July 10, 2019

Re: Regional Arterials Study, "Draft June 2019"

The City of Rollingwood appreciates the opportunity to comment on the Regional Arterials Study. As part of the current process phase of "Draft June 2019" during the Public Open House for the Regional Arterials Study, the City of Rollingwood respectfully submits the following comments regarding current and future safety and connectivity needs in view of the "vision network" presented in the "Arterials Boards". The City of Rollingwood is a primary connector point for most of Western Travis County and desires to see improvements to the safety, mobility, economy, and environment of multimodal transportation choices along the roadways that intersect and border the City of Rollingwood and provide connectivity to downtown Austin.

(1) As to the “existing” map on page 7 of the “Arterial Boards”:

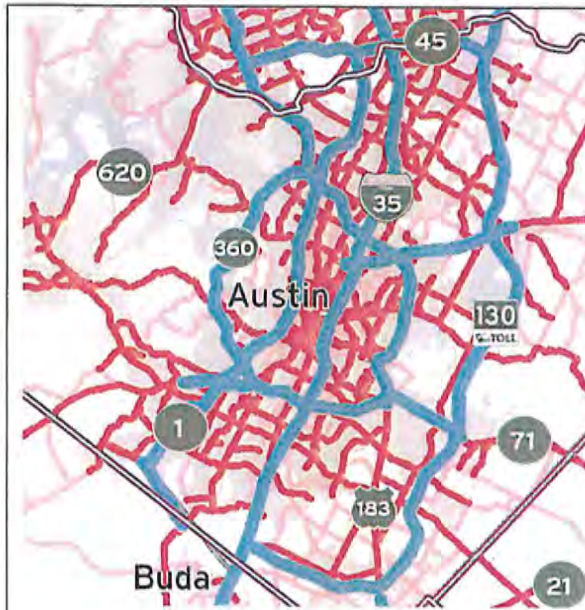
<p>(a) Loop 1 is classified, from 45N to the 45SW, as a “limited access” segment, a “principal arterial” segment, a “limited access” segment, a “principal arterial” segment, a “limited access” segment and a “principal arterial” segment. The Regional Corridor Inventory previously provided to the City of Rollingwood does not reflect a separate description for each of these alleged segments, and also does not include any project description for Loop 1 South of Cesar Chavez.</p> <p>(b) In addition, it is unclear from the Arterial Boards what criteria is used to label a segment of a roadway as “limited access” or “principal arterial”. There are portions of Loop 1 illustrated that include “managed lanes” and are labeled as both a “principal arterial” and “limited access” and there are portions of Loop 1 illustrated that do not include managed lanes and are labeled as both a “principal arterial” and “limited access”.</p> <p>(c) Bee Caves Road is shown as a “principal arterial” from east to west, however, the Regional Corridor Inventory describes 9 segments of Bee Caves Road.</p> <p>(d) It is unclear whether the Regional Corridor Inventory previously provided to the City of Rollingwood was informed by the “existing” map on page 7 of the “Arterial Boards” or whether the Regional Corridor Inventory has been updated to reflect the “existing” map.</p>

(2) As to the “planned” map on page 7 of the “Arterials Boards”, based on the “2040 Planned Network”:

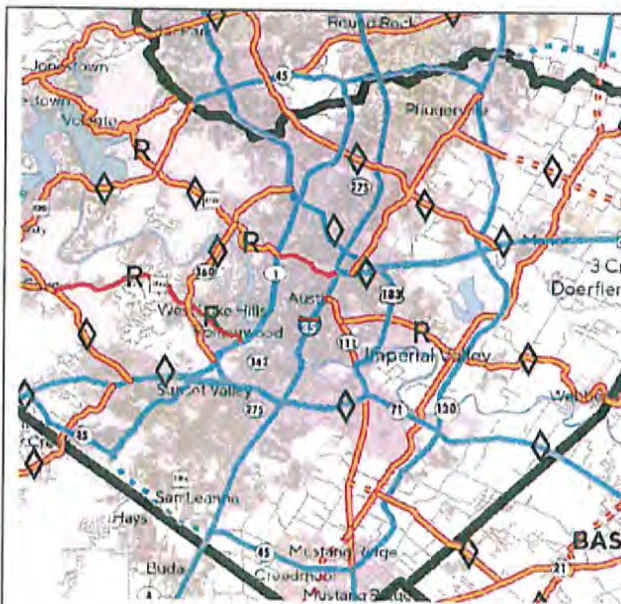
(a) Loop 1 is classified, from 45N to the 45SW, as a “limited access” segment. The Regional Corridor Inventory previously provided to the City of Rollingwood does not provide any description of any planned improvements to Loop 1 to support the “planned” map.

(b) Based on project descriptions in the CAMPO 2040 plan, the “planned” map appears to show primarily “managed lane” planned roadways as the “limited access” roadways.

(c) The CAMPO 2040 Plan specifically segments planned updates to Loop 1 South between the limits of Cesar Chavez and Slaughter Lane, but provides no planned improvements between Slaughter Lane and 45SW.

(d) It is unclear whether the Regional Corridor Inventory previously provided to the City of Rollingwood was informed by the “planned” map on page 7 of the “Arterial Boards” the CAMPO 2040 plan, or whether the Regional Corridor Inventory has been updated to reflect the “planned” map or CAMPO 2040 plan.

(3) As to the “Scenario A” map on p. 8 and “Scenario B” and “Scenario C” maps on p. 9 of the “Arterials Boards”:

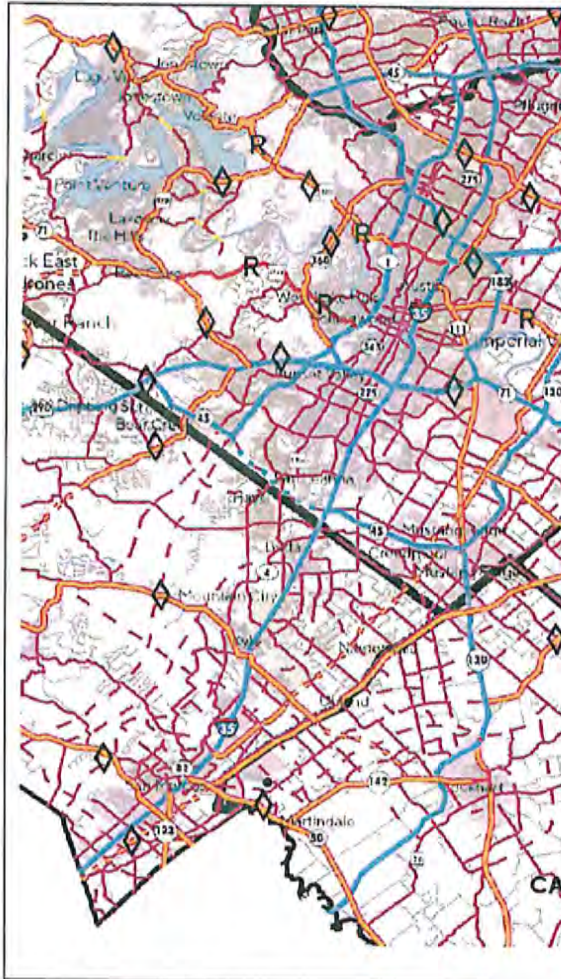
(a) In “Scenario A”, “Scenario B”, and “Scenario C”, Bee Caves Road is proposed as including a “reversible lane” scenario. P. 5 of the “Arterial Boards” shows the only potential design option for a reversible lane by repurposing a center turn lane as a reversible lane. It is unclear from the Regional Corridor Inventory that the “improvement” listed under regional project number 90.1 of Bee Caves Road as an undivided 4 lane road, would contemplate using the almost completed safety improvement of a center turn lane between Loop 360 and Rollingwood Drive, as a reversible lane, instead of a center turn lane.

(b) In “Scenario A”, “Scenario B”, and “Scenario C”, it is unclear why a dotted line is proposed between the southern point of Loop 1 and I-35 as a “limited access” roadway, but the existing improvements, of both SH45SW, which is shown on both the “existing” and the “planned” maps, and the upgrade of FM 1626 from a “minor arterial” in the existing map to a “principal arterial” in the “planned” map, are not considered. The City of Rollingwood has commented in the past requesting that the traffic impacts on Mopac South due to the constructions of SH45SW and the upgrade to FM1626 have not yet been adequately measured; the City of Rollingwood is opposed to converting Loop 1 into an I-35 bypass, to the detriment of local traffic, which would be effected if Loop 1 is designed with express lanes directly connected to I-35 South of downtown Austin to I-35 North of downtown Austin.
